BROWNS FERRY NUCLEAR PLANT (BFN) – UNITS 1, 2, AND 3 – TECHNICAL SPECIFICATIONS (TS) CHANGES TS-418 AND TS-431 – EXTENDED POWER UPRATE (EPU) – RESPONSE TO ROUND 23 REQUEST FOR ADDITIONAL INFORMATION (RAI) REGARDING STEAM DRYER SIGNAL PROCESSING (TAC NOS. MD5262, MD5263, AND MD5264)

**TENNESSEE VALLEY AUTHORITY
BROWNS FERRY NUCLEAR PLANT (BFN)
UNITS 1, 2, AND 3**

**TECHNICAL SPECIFICATIONS (TS) CHANGES TS-431 AND TS-418
EXTENDED POWER UPRATE (EPU)**

**RESPONSE TO ROUND 23 REQUEST FOR ADDITIONAL INFORMATION (RAI)
REGARDING STEAM DRYER SIGNAL PROCESSING**

Figure EMCB.203-1.18a: Cross spectra (top) and coherence (bottom) of coherence filtered data for BFN1 main steam line A, for CLTP conditions (black) and LF conditions (blue).

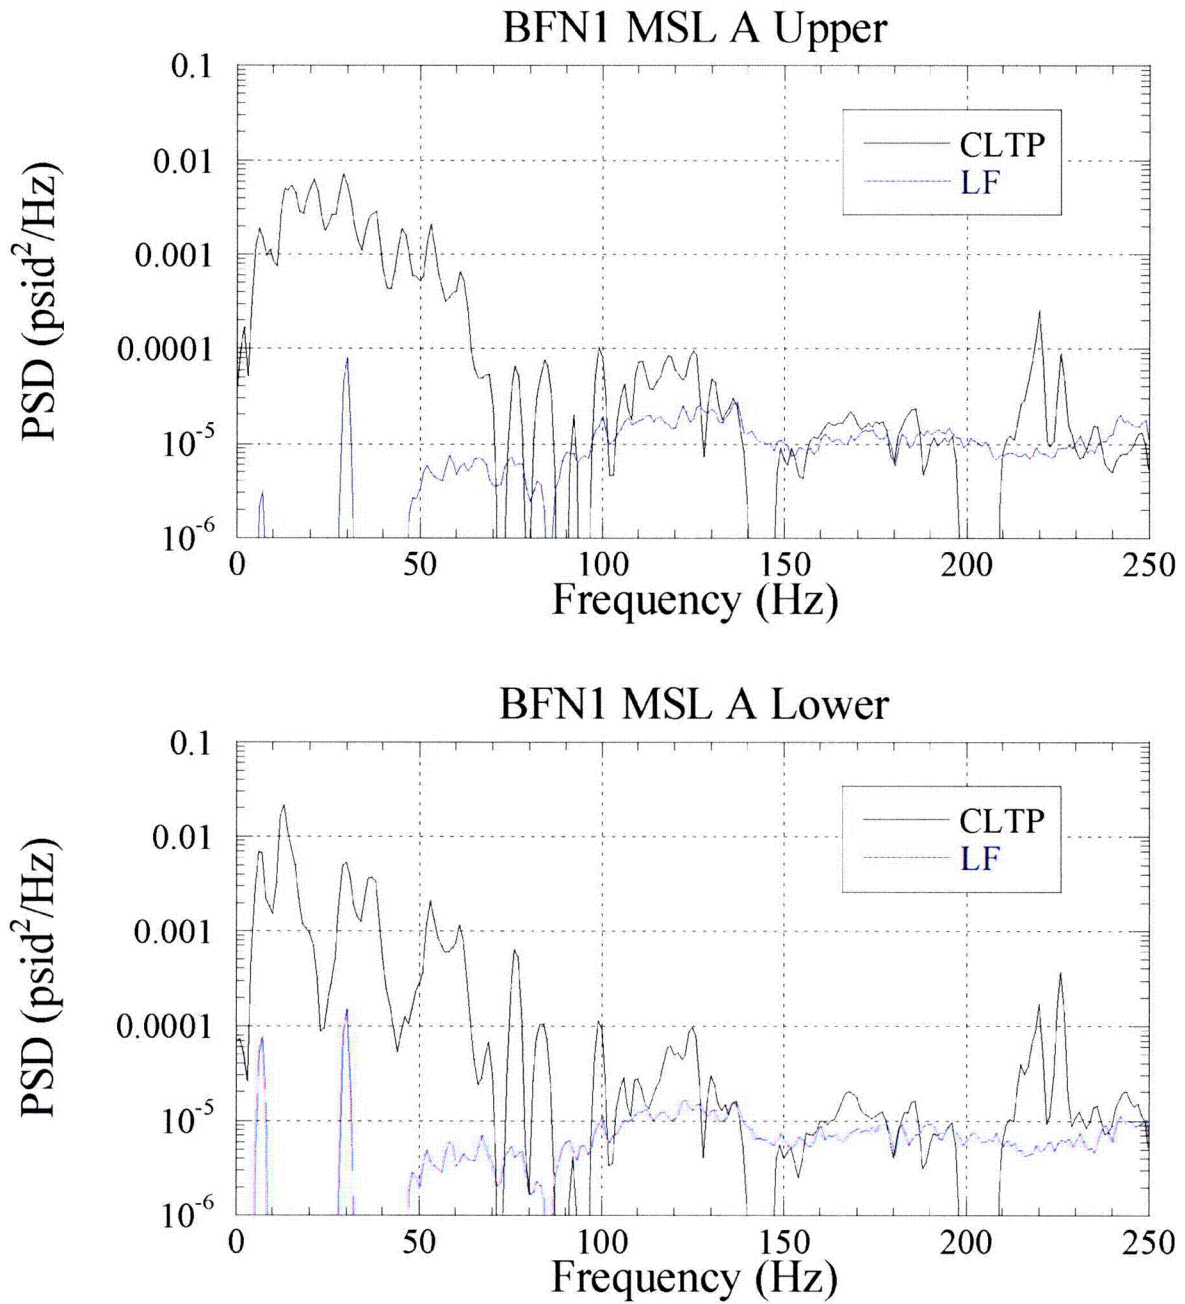
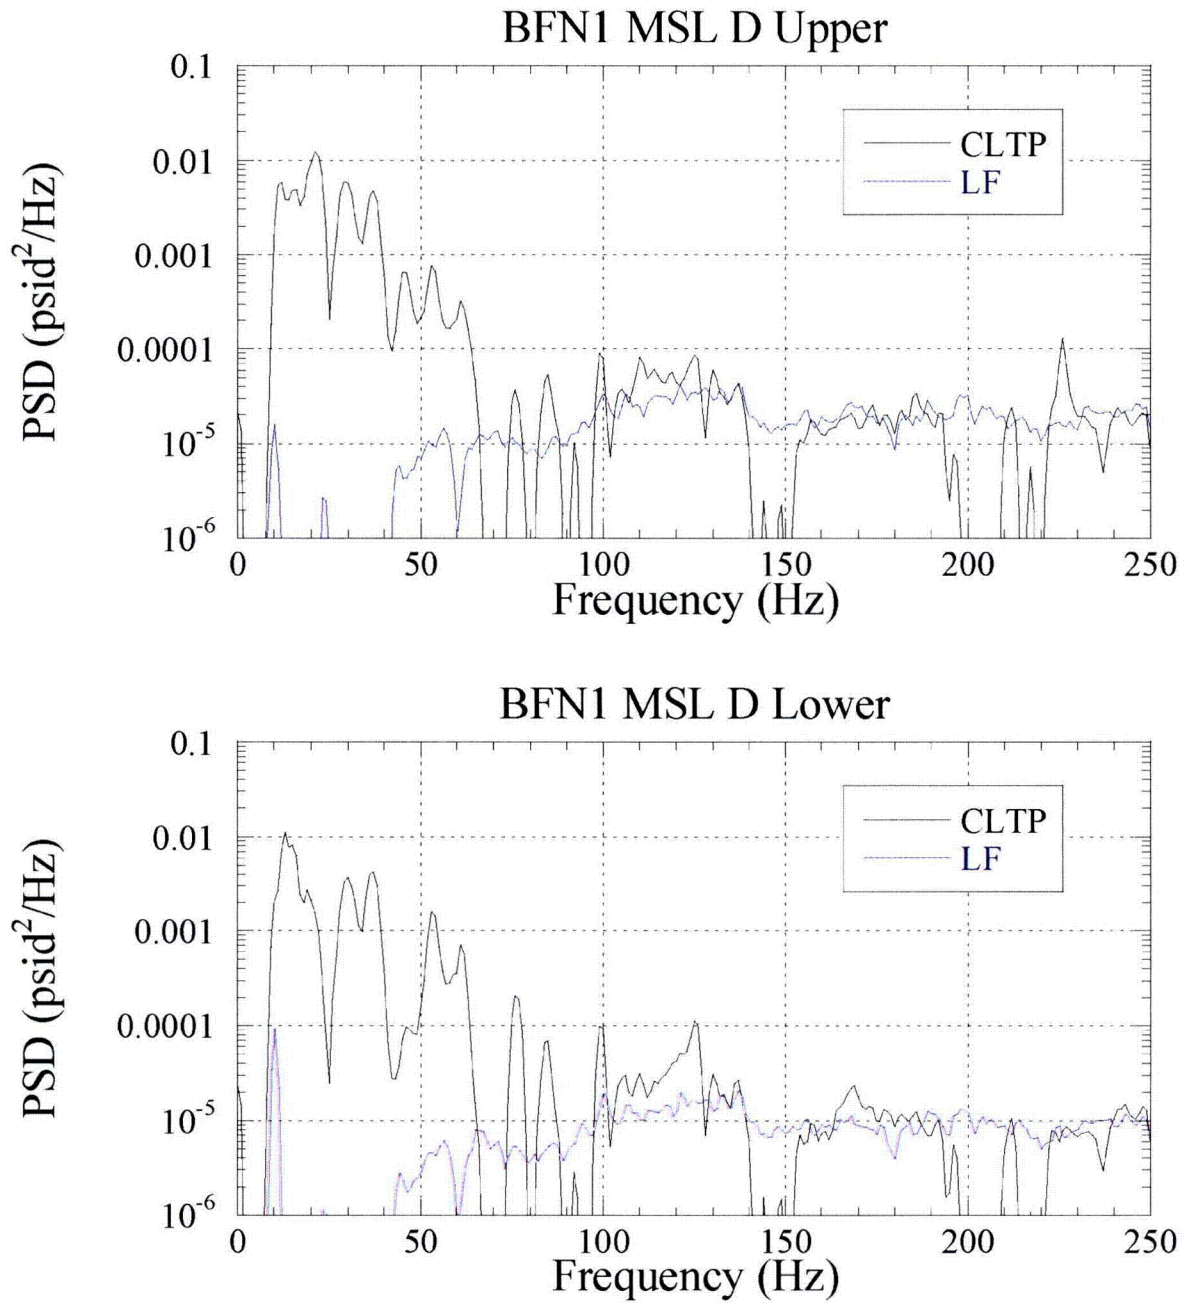
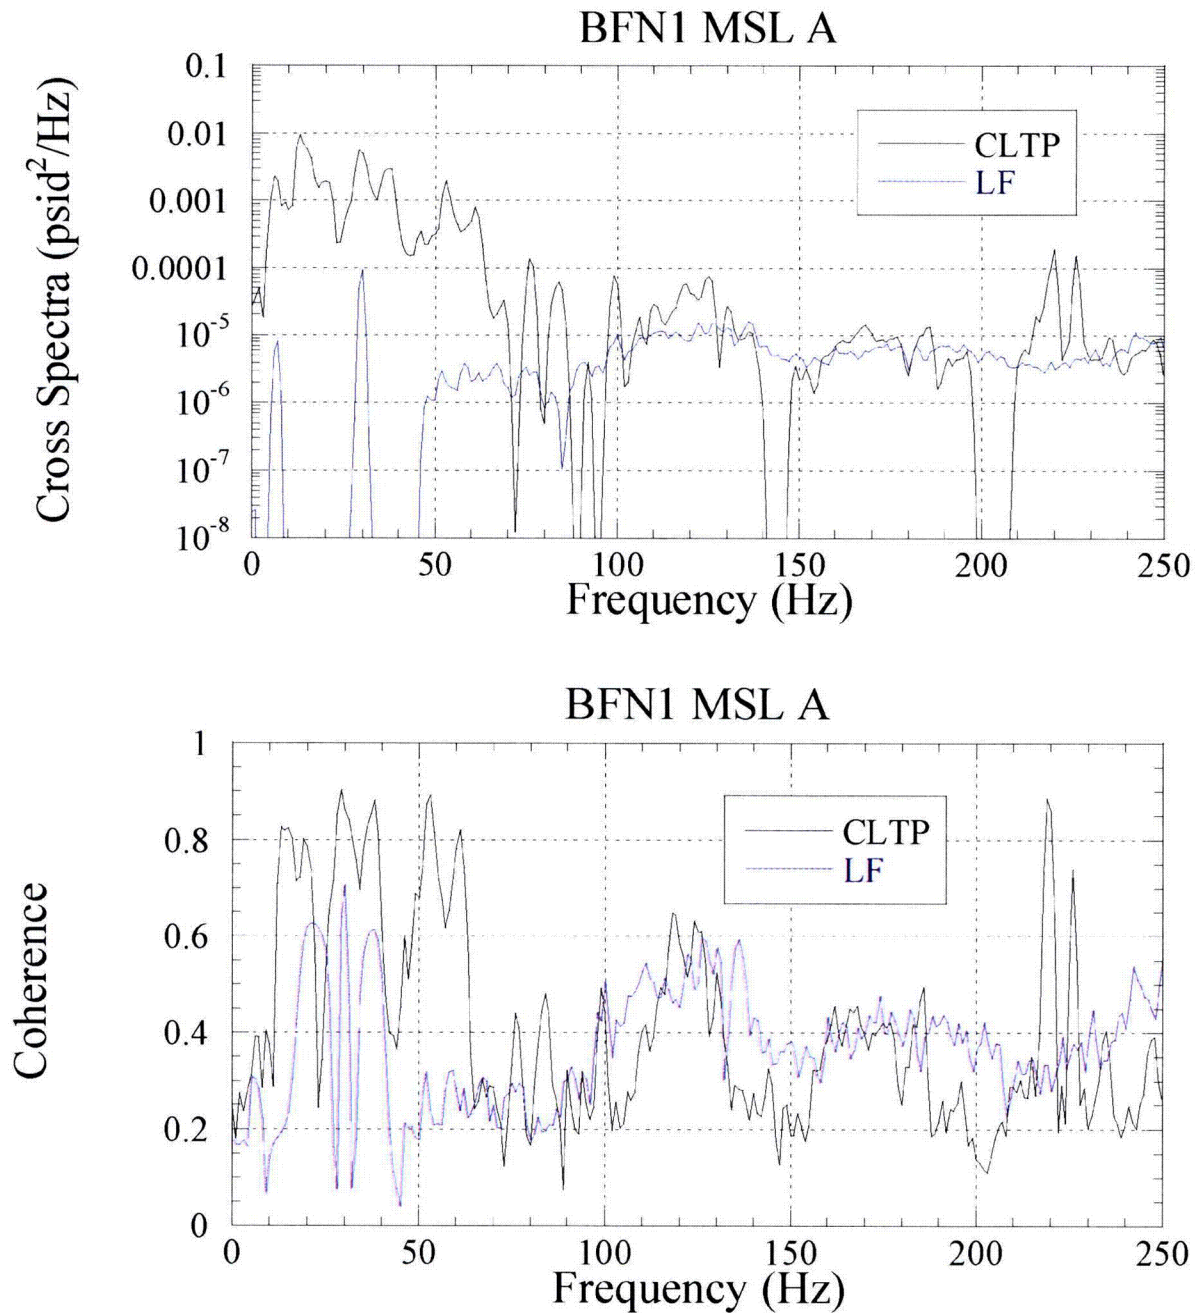
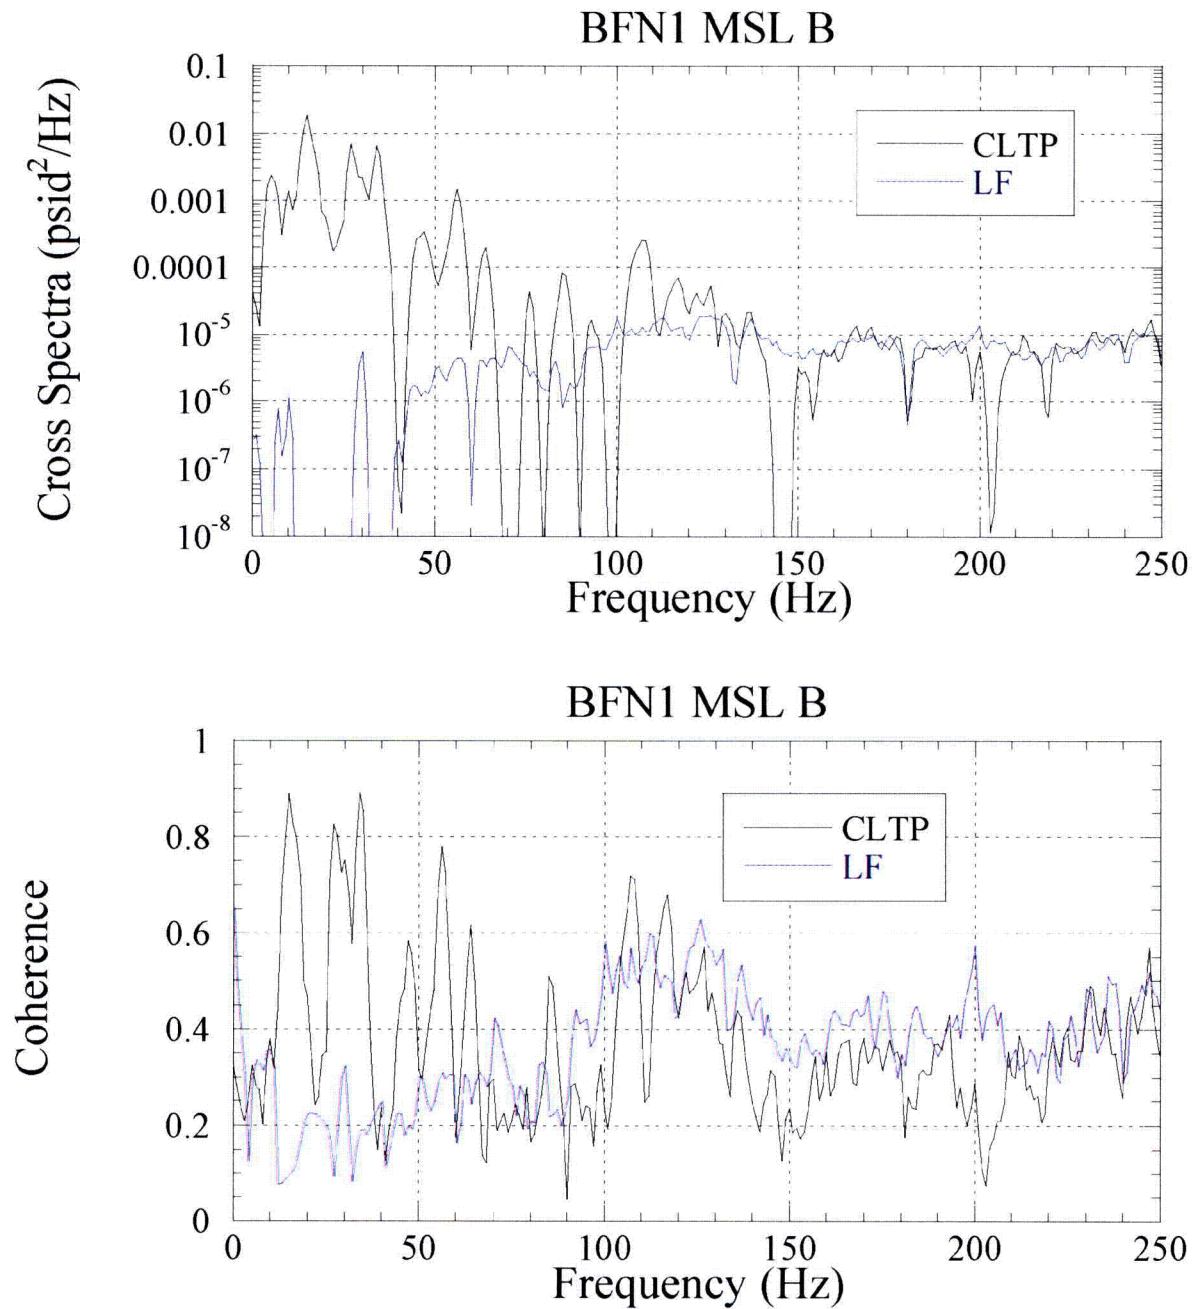
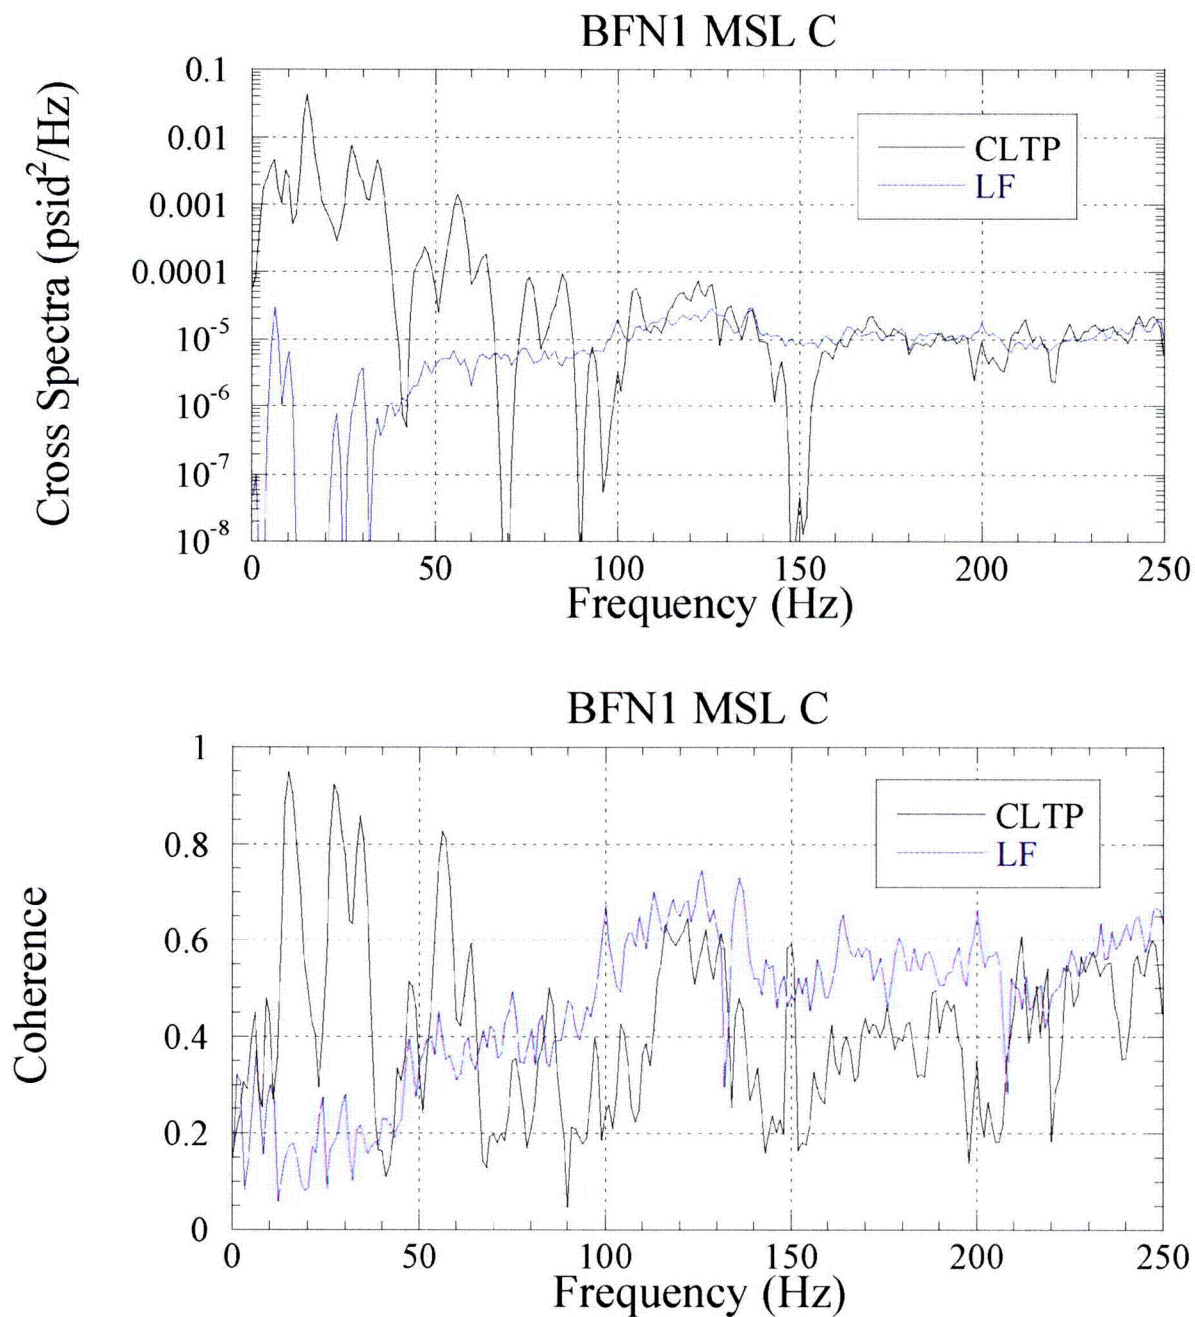
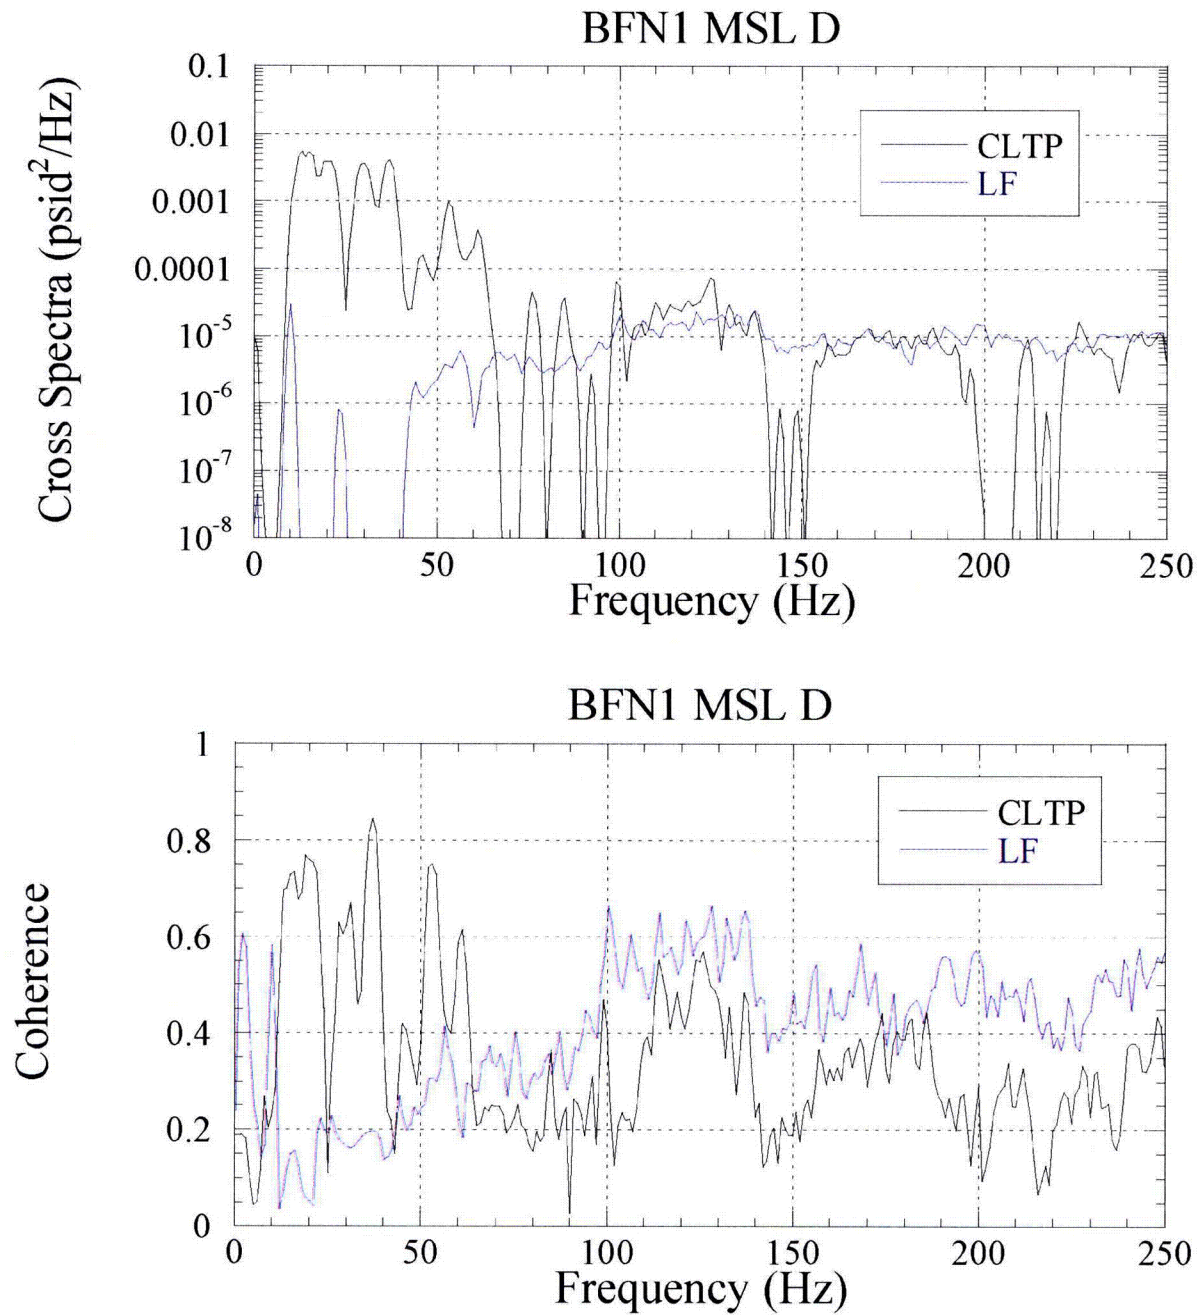
In response to EMCB.200/157., TVA presents detailed discussion of signal conditioning in six steps. Provide plots of strain gage signals (autospectra, cross spectra, coherence, and phase) and computed [[]] throughout the procedure described in their RAI response (prior to step 1, after step 1, after step 2, after step 4 and after step 6), for current license thermal power (CLTP) and Low Flow (LF) signals, for Units 1 and 2.

After Step 4: apply coherence and mean filter
